## MODULARIS Uro

### Update Instructions

**SP001/03/S**

Title: Reinforcement of tabletop

Fig. 1

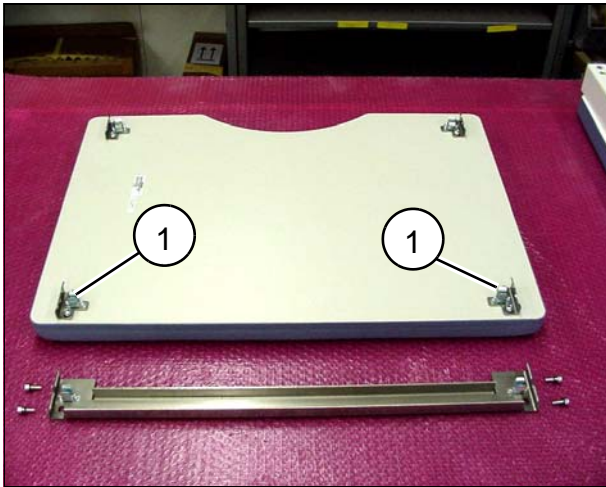
- Move the tabletop upwards.
- Remove both mounting clips (1/Fig. 1 and 1/Fig. 2) from the back side of the tabletop.
- Position the rail according to (Fig. 3) and loosely screw it on with the supplied screws (1/Fig. 4).
- Position the top on the table so that the clips lock in place and the strut is in alignment.
- Tighten the screws from underneath (1/Fig. 4).

Fig. 5

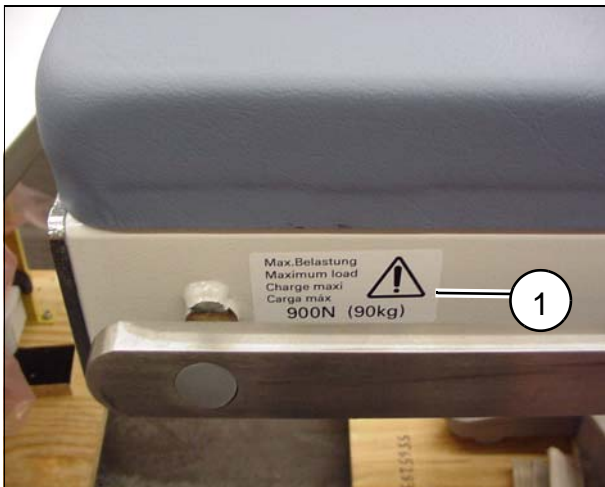
- Attach the stick-on label (1/Fig. 5) on both sides of the table.
